Fixing Priority Encoding in 802.16k

IEEE C802.16k-06/001

Correct the encoding of user_priority and access_priority in the M_UNITDATA.req primitive onto 802.16 frames

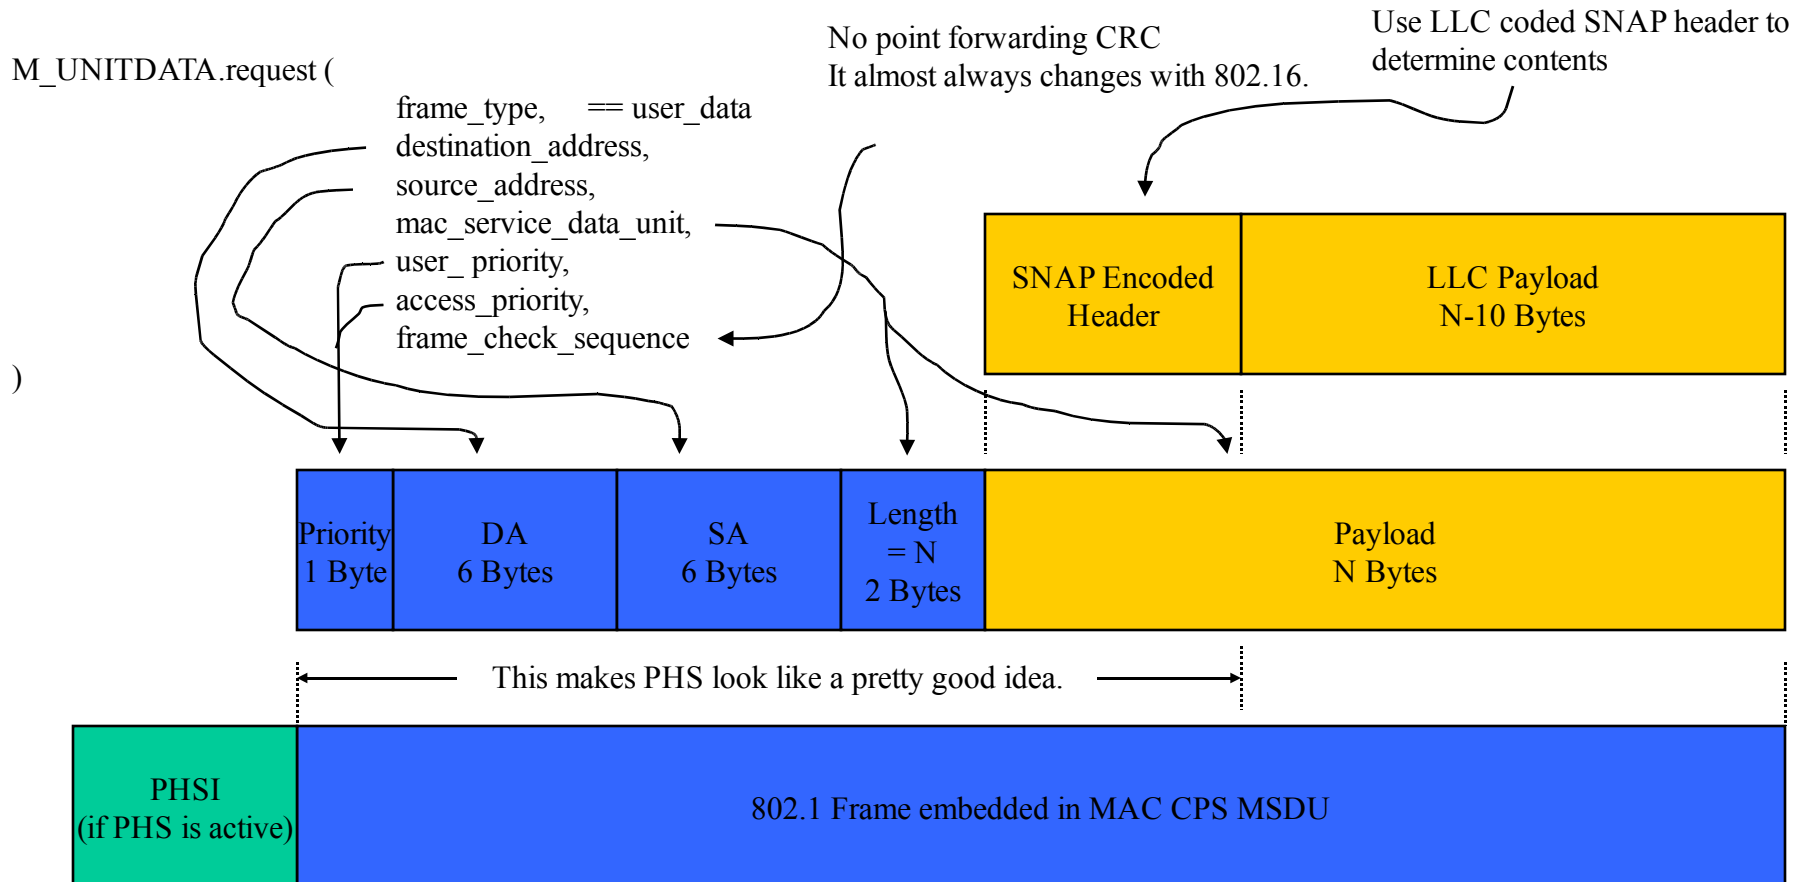
Solution

- Replace ISSP with Priority byte
- Encode priority as a 3 bit value
- Encode in 3 MSBs to allow lower significance bits to have effect in the future
